**A30 Chiverton to Carland Cross  
TR010026**

**8.21 RESPONSES TO THE EXAMINING  
AUTHORITY'S SECOND WRITTEN  
QUESTIONS**

June 2019

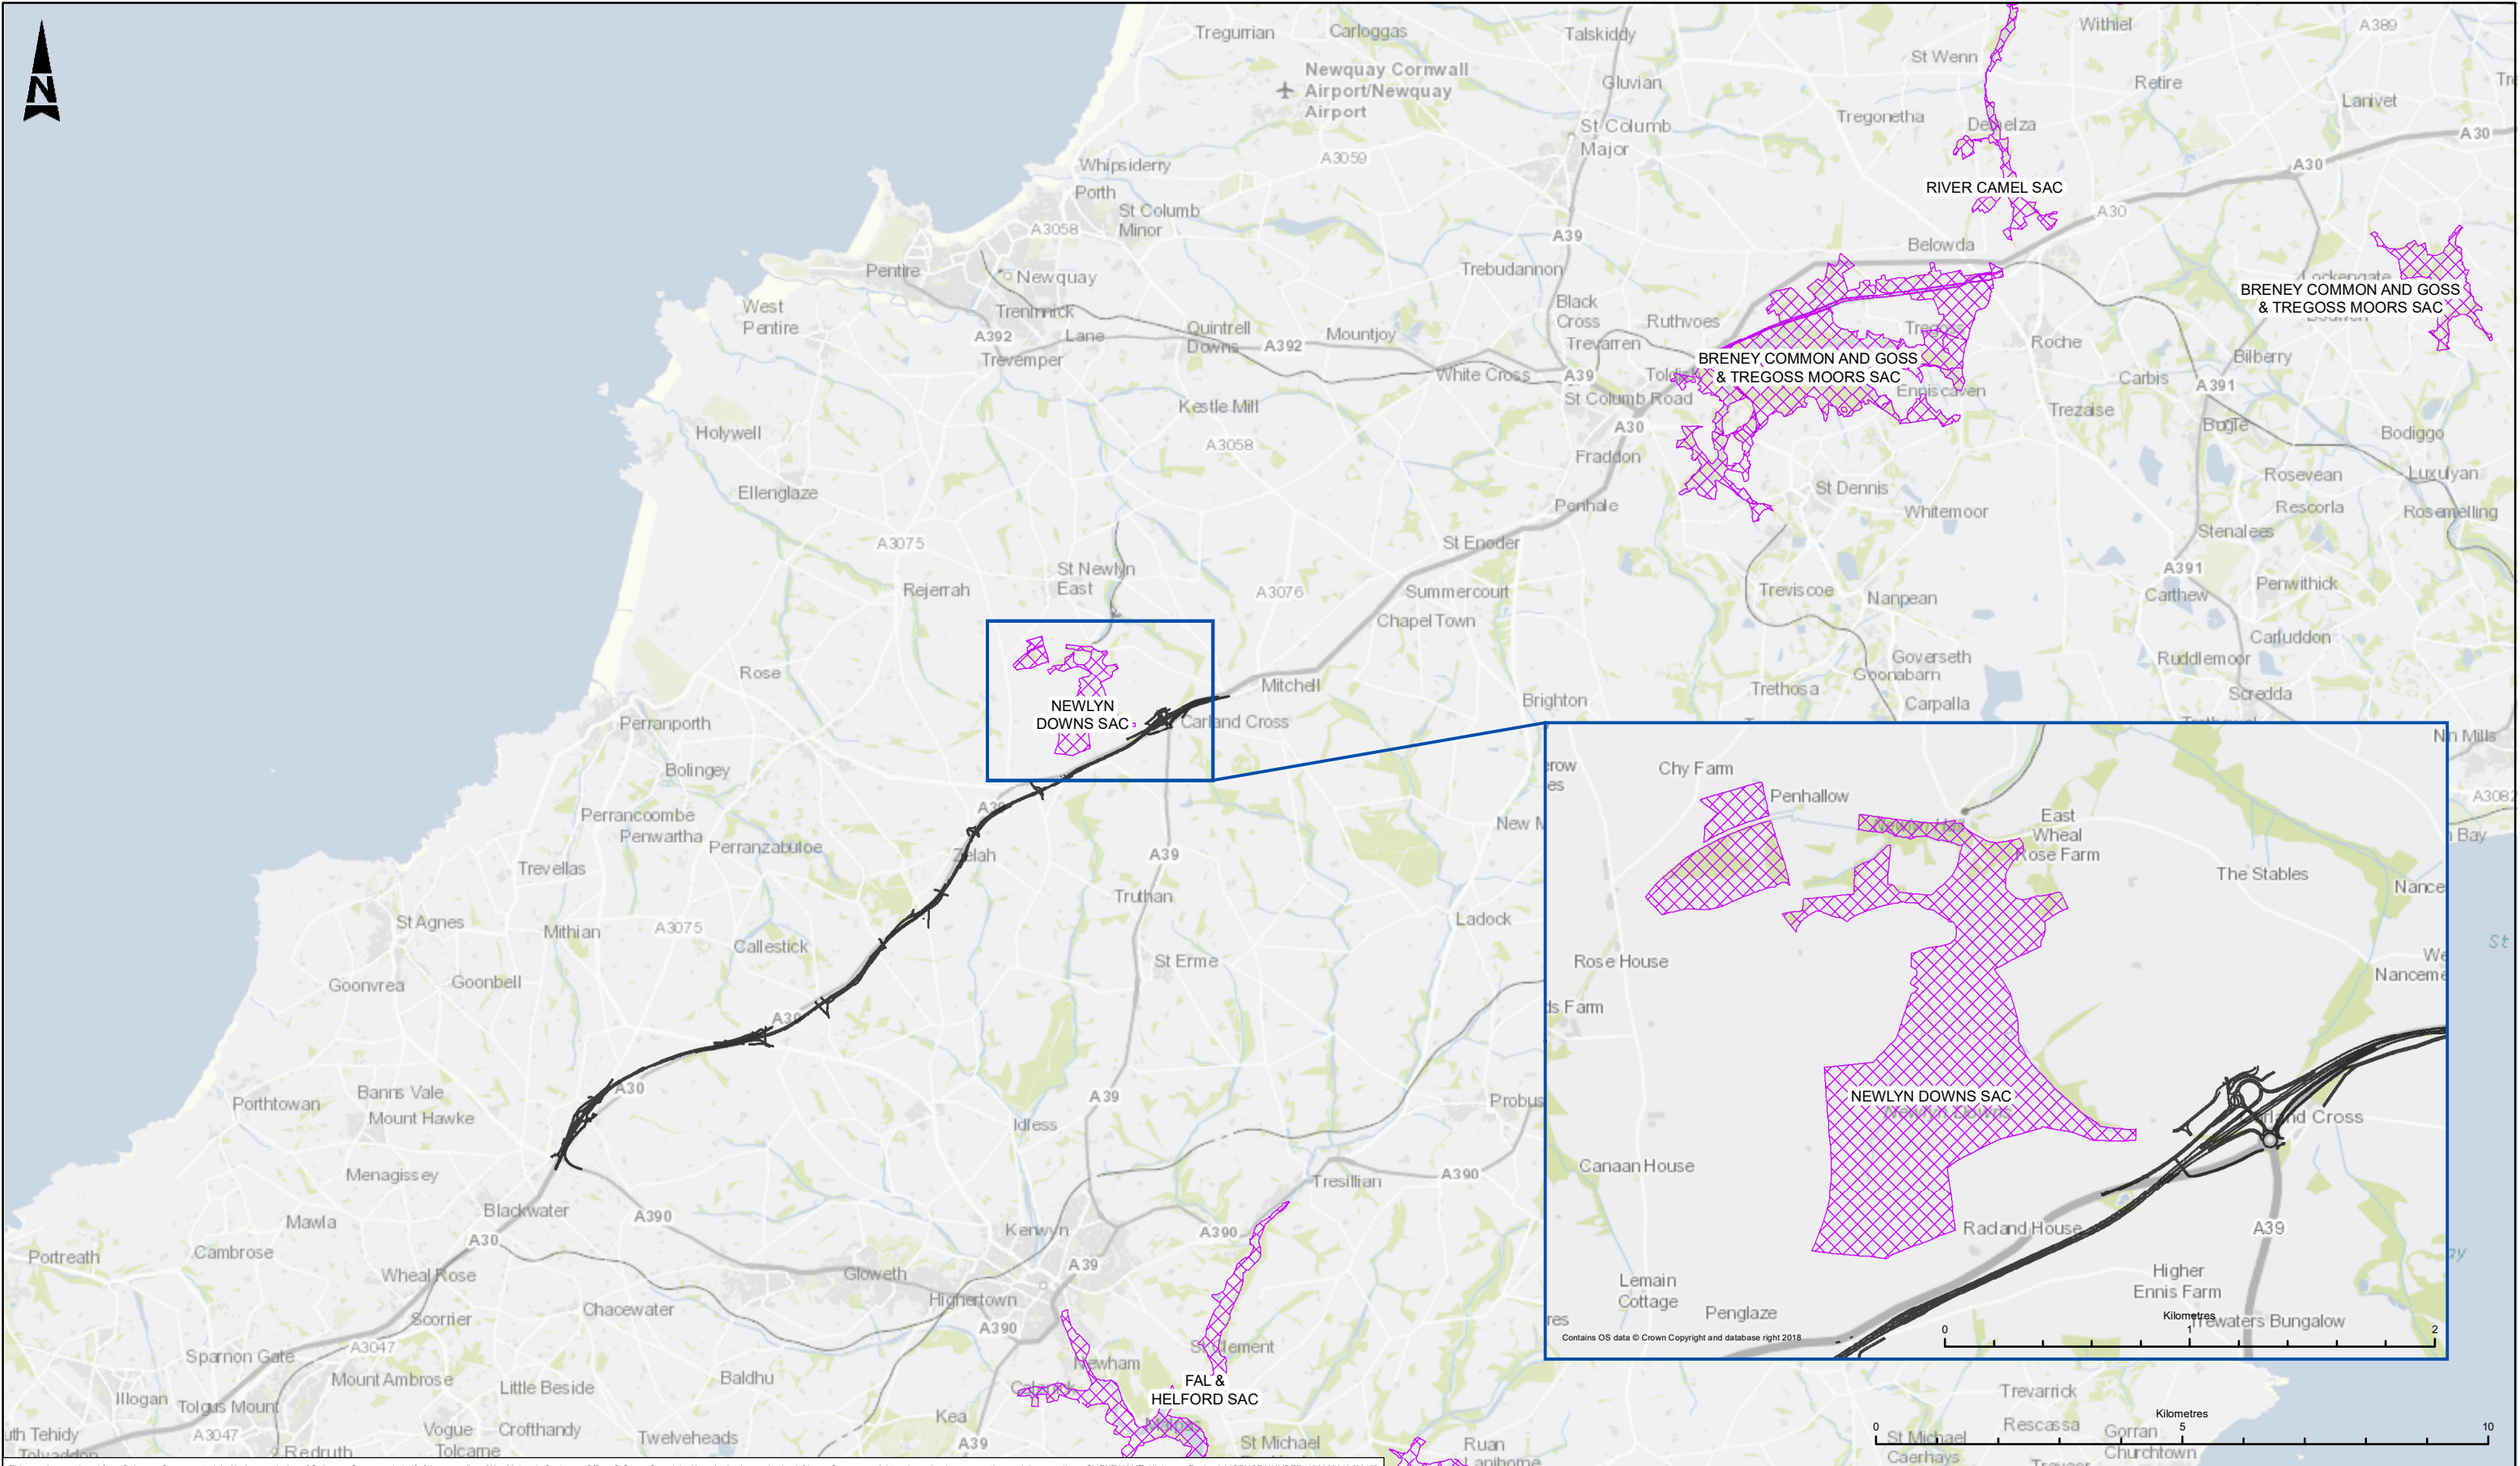
2.11.1	Applicant	<p>Please respond to the comments raised in relation to Pennycomequick [REP4-009] regarding road safety and traffic conflict.</p>	<p>The Harvey Family submission at Deadline 4 [REP4-009] states: <i>“Our concerns remain over the potential conflict between horses/riders, cyclists and pedestrians on the one hand and motorists who will be encouraged by better visibility over the improved section to drive more quickly. HE considers that there will not be a problem and refuses to do anything. We have to hope that they are correct and not negligent in their assumptions.”</i></p> <p>The improved visibility provided on the realigned section of Pennycomequick Lane (C0075) would also provide improved visibility for motorists to any walkers, cyclists and horse riders in this section. It is not considered that the realignment of this lane would increase the risk of any potential conflict.</p> <p>The Harvey Family submission at Deadline 4 [REP4-009] states that realigning the C0075 prior to the use of the compound <i>“would just as importantly reduce most of the conflicts between agricultural traffic (which would continue to use the existing lane) and construction plant and by taking the pressure off the existing blind corner, hopefully preventing the otherwise inevitable accidents that result.”</i></p> <p>To manage traffic during construction, a draft <b>Traffic Management Plan</b> is included in Appendix 2.1 of the Environmental Statement (Document Reference 6.4) [APP-300-309].</p> <p>Traffic management proposals for the construction of this section of the works are required to be further developed prior to the construction of the scheme in the Traffic Management Plan under Requirement 11 of the <b>draft DCO</b> (Document Reference 3.1(E)). Any proposals would be developed in consultation with Cornwall Council as the local highway authority.</p> <p>The proposed construction compound is located adjacent to the existing C0075. The compound has to be installed first to facilitate the construction of the</p>

Number	Directed to	Question	Applicant's Response
			<p>realigned C0075. The Traffic Management Plan would seek to separate construction traffic and other traffic as much as possible.</p> <p>As part of installing the compound, the reduced visibility through the existing road corner adjacent to the proposed compound location would be improved to provide the required distance for safe visibility.</p>
<b>12. WATER ENVIRONMENT</b>
